SERVICE BULLETIN

SB1252

VEHICLE MODEL : C2045, CX35, CX45, TX40, TX45

SUBJECT: To change weather strip mounting lip of luggage

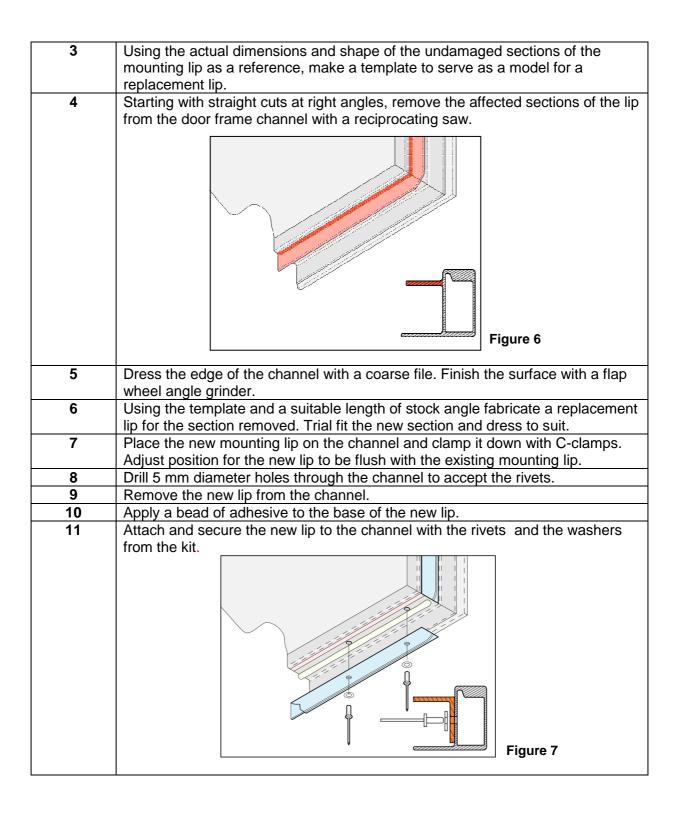
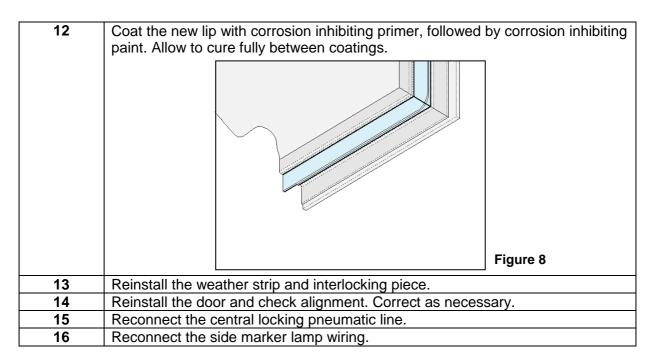
Step	Action
1	Detach the weather strip from the door in its entirety.
2	Determine the extent of the corrosion damage and mark the sections to be removed.
	Figure 5
